**General Bid Bulletin No. 23
25 August 2021**

RESPONSES TO CLARIFICATIONS

IFB No. 21-058-5; South Commuter Railway Project for Package Number CP S-03b; Civil Engineering, Tunnel and Building Works for Approximately 6.1km Railway with 4.7km of Underground Railway and 1.4km of At-Grade Railway, Including FTI Station and Tunnelling Works to Connect to MMSP Senate Station

General Bid Bulletin No. 23
 CP-S03B Responses to Clarification Requests (Batch 9 to 11)

Annex 1

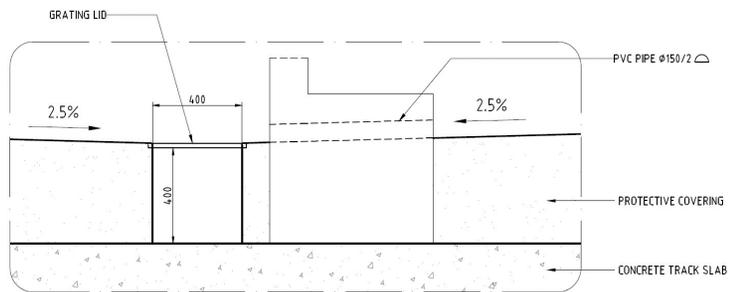
455	Bid Addendum 3 Volume 2 NSRP FTI Station CP S-03b: Detailed Design Structural Drawings		NSRP-DWG-FTI-ST-4411	FTI Station Steelworks Roof Details-Sheet 1	Catenary Support details	In the notes stated in the drawing, it is indicated that catenary support details will be designed by others. Kindly clarify if it is the scope of the bidder since in the BOQ, there's a provided quantity for the structural steel of the catenary support however, there are no provided details and locations for this item.	<p>The wording has been amended to:</p> <p>Refer to drawing NSRP-DWG-FTI-AR-3301 for the Catenary Support Details. Overhead Catenary System is designed by others.</p> <p>NSRP-DWG-FTI-ST-4411 revision 21.5 will be issued with Bid Addendum 5</p>				
456	CP S-03b Vol 2 Part II Sec 6 IC TS 700 Electrical Works Bid Addenda 1 20210514		TS-700 Addenda 1 pg. 103-134			Kindly confirm if Fire Detection and Alarm System requires PC-based Workstation in both At-Grade and Underground Stations.	<p>The TS-700 specifications refer to the Build only scope only, the Design and Build specifications are provided in the ODS and the UTS Specifications:</p> <p>- UTS CIVIL 100-200-300-500-600-700</p> <p>- UTS ARCH 800-900-1000-1000</p> <p>- UTS MEP 1100-1200</p>

Annex 2

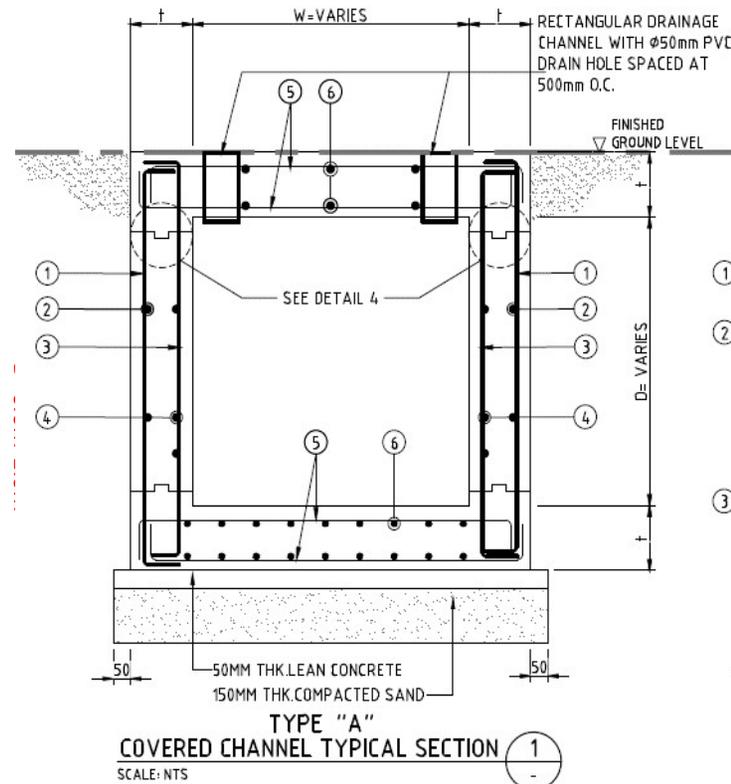
135	Volume 1A Section 4A Bill of Quantities		Bill No.5	Pay Item No. 506(12) Stainless Steel Grating	N/A	Kindly specify in the plans where will the stainless steel grating will be installed.	<p>Refer to NSRP-DWG-FTI-AR-3515, rev. 21.3 and NSRP-DWG-FTI-AR-3603, rev.21.3 which will be provided with Bid Addendum 3.</p>				
136	Volume 2 Package 03b Detailed Design Structural Drawings		NSRP-DWG- ATG-ST- 4207	N/A	VIA03b AT GRADE REINFORCEMENT DETAILS	Please confirm if the transverse rebar (U2) for slab has a diameter of 16mm only unlike other transverse bars (ex. U7) with size of 36mm dia. Refer to Annex 1.	<p>Yes, the Bidder's understanding is correct.</p>				
137	Volume 2 Package 03b Detailed Design Structural Drawings		NSRP-DWG- ATG-ST- 4203	N/A	VIA03b AT GRADE PROTECTIVE CONCRETE	Please confirm if the minimum thickness of protective concrete in at-grade typical sections 4-6 is 400mm. Refer to Annex 2.	<p>Yes, the Bidder's understanding is correct.</p>

Annex 4

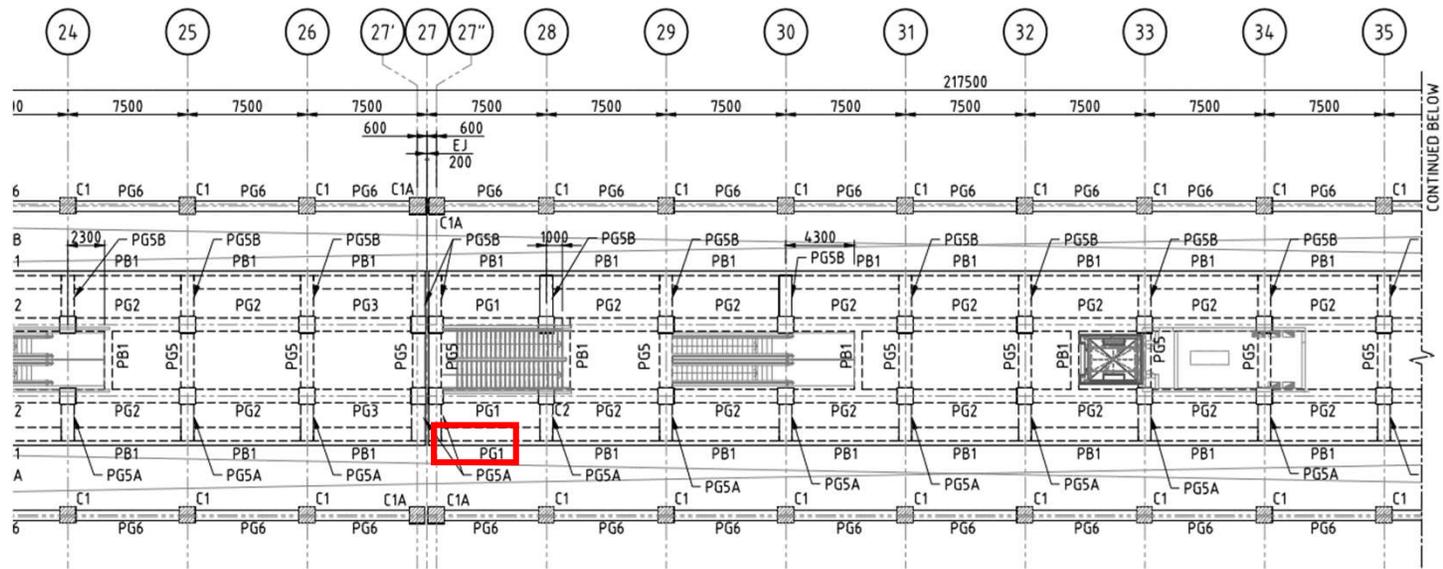
1) The Bidder is advised that Item No. 408(1) shall include the following: (a) Roof Framing for the Pedestrian Overpass as shown in drawing nos. NSRP-DWG-FTI-ST-4716, 4721 & 4722 Rev21.3; and (b) Roof Framing on MMSP Rail Track as shown in drawing nos. NSRP-DWG-FTI-ST-4901, 4902, 4921, 4922 & 4941 Rev21.2. 2) The bidder is further reminded that Item 408(11) shall be exclusive to the PTFE Tension Membrane Roofing.				
148	Volume 2 NSRP FTI Station Package CP 5-03b: Detailed Design Structural Drawings		NSRP-DWG-FTI-ST-4101	FTI Station Structural Plans Foundation Plan/Column Layout	Wall Schedule		In the wall schedule, Retaining wall(RW30) is indicated however, its location is not shown in the drawing. Please provide.				
							Legend for RW30 will be added to the drawing. Please refer to NSRP-DWG-FTI-ST-4101 rev 21.3 which will be included in Bid Addendum 3.				
149	Volume 2 NSRP FTI Station Package CP 5-03b: Detailed Design Structural Drawings		NSRP-DWG-FTI-ST-4101	FTI Station Structural Plans Foundation Plan/Column Layout	Dowel bars		Kindly confirm if the dowel bars indicated in the notes in drawing no. 4101 is included in the pay item for reinforcement of NSRP At-Grade station. See Annex 4.

Annex 6

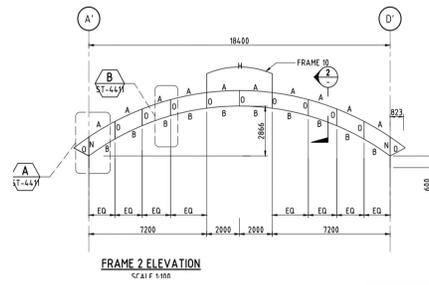
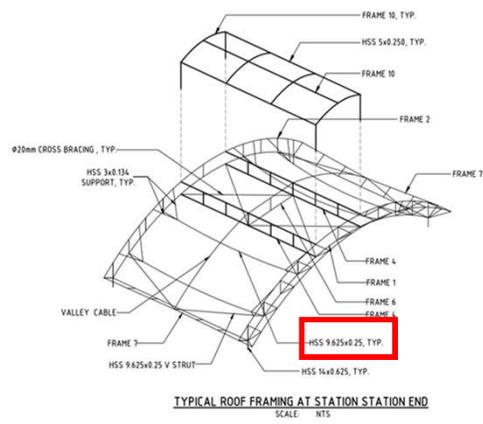
The quantity of concrete for bond beam is included in PIN 405(10)b -- Structural Concrete, Class "AAA" (31 Mpa), the revised BOQ will be provided with Bid Addendum 3.				
152	Volume 2 NSRP FTI Station Package CP 5-03b: Detailed Design Structural Drawings		NSRP-DWG-FTI-ST-4331	FTI Station Concrete Works-Schedules and Details Slabs and Walls	Wall Schedule		In NSRP-DWG-FTI-ST-4331, W25 is indicated in the wall schedule however, it is not identified in the drawing. Kindly provide its location.				
							W25 shall be indicated in drawings NSRP-DWG-FTI-ST-4201 to 4203 and NSRP-DWG-FTI-ST-4211 to 4213 to be updated and issued as rev 21.3 and included with Bid Addendum 3.				
153	Volume 2 NSRP FTI Station Package CP 5-03b: Detailed Design Structural Drawings		NSRP-DWG-FTI-ST-4401 NSRP-DWG-FTI-ST-4402 NSRP-DWG-FTI-ST-4403	FTI Station Steelwork-Roof Framing Typical Details FTI Station Steelwork-Roof Framing Details Sheet 1 and Sheet 2	N/A		In the figure for the typical roof framing, the steel section is labeled as HSS 3x0.134 however in the member schedule, it is HSS 3.5x0.188. Kindly confirm. See Annex 6.

Steel HSS 3.5x0.188 is the confirmed section. Please refer to drawings NSRP-DWG-FTI-ST-4401 to 4403 rev 21.2 as included in Bid Addendum 2 for the updated section label				
154	Volume 2 NSRP FTI Station Package CP 5-03b: Detailed Design Structural Drawings		NSRP-DWG-FTI-ST-4401 NSRP-DWG-FTI-ST-4402 NSRP-DWG-FTI-ST-4403	FTI Station Steelwork-Roof Framing Typical Details FTI Station Steelwork-Roof Framing Details Sheet 1 and Sheet 2	N/A		In the figure for the typical roof framing, the steel section is labeled as HSS 9.65x0.25 however in the member schedule, it is HSS 9.625x0.312. Kindly confirm. See Annex 7.				
							Steel section for V strut is HSS 9.625x0.312. NSRP-DWG-FTI-ST-4401 will be updated and issued as rev 21.3 and included in Bid Addendum 3.				
155	Volume 2 NSRP FTI Station Package CP 5-03b: Detailed Design Structural Drawings		NSRP-DWG-FTI-ST-4401 NSRP-DWG-FTI-ST-4402 NSRP-DWG-FTI-ST-4403	FTI Station Steelwork-Roof Framing Typical Details FTI Station Steelwork-Roof Framing Details Sheet 1 and Sheet 2	N/A		In the figure for the typical roof framing, the steel section is labeled as HSS 14x0.625 however in the member schedule, it is HSS 16x0.5. Kindly confirm. See Annex 8.

Annex 11

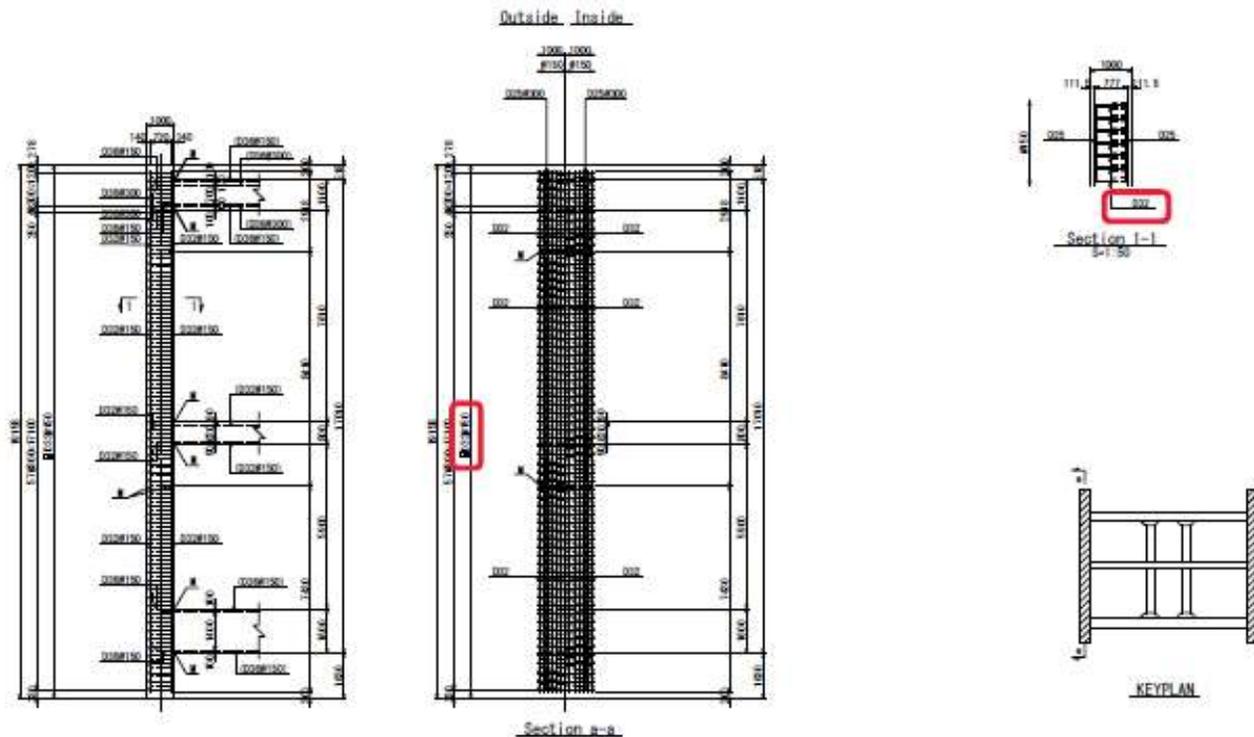
158	Volume 2 NSRP FTI Station Package CP 5-03b: Detailed Design Structural Drawings		NSRP-DWG-FTI-ST-4141 NSRP-DWG-FTI-ST-4401	FTI Station Structural Plans Lower Roof Framing Plan FTI Station Steelwork-Roof Framing Typical Details	N/A	In the lower roof framing plan, the frame at expansion joint is Frame 2 however in the typical roof framing it is stated that it is frame 3. Please confirm. See Annex 11	This is confirmed. Please refer to NSRP-DWG-FTI-ST-4401 rev 21.2 submitted with Bid Addendum 2 for the frame designations.				
159	Volume 2 NSRP FTI Station Package CP 5-03b: Detailed Design Structural Drawings Volume 1A Section 4A Bill of Quantities		NSRP-DWG-FTI-ST-4501 to 4541 NSRP-DWG-FTI-ST-4801 to 4801 Bill No. 5	FTI Station-Plant Building FTI Station-Temp. Emergency Staircase Exit 1 Pay item No. 405(9) Structural Concrete, Class "AAA" (31 MPa) for Elevated Slab/Concrete Stairs/Concrete Gutter.	Slab on grade	Kindly confirm if the slab on grade for Plant Building and Temporary Emergency Staircase will be included in pay item no. 405(9)b.	Slab on grade for Plant Building and Temporary Emergency Staircase will be included in Bill No. 5 as PIN 405(1)c -- Structural Concrete, Class "AAA" (36 Mpa) for Mat / Raft Foundation. The revised BOQ will be provided with Bid Addendum 3
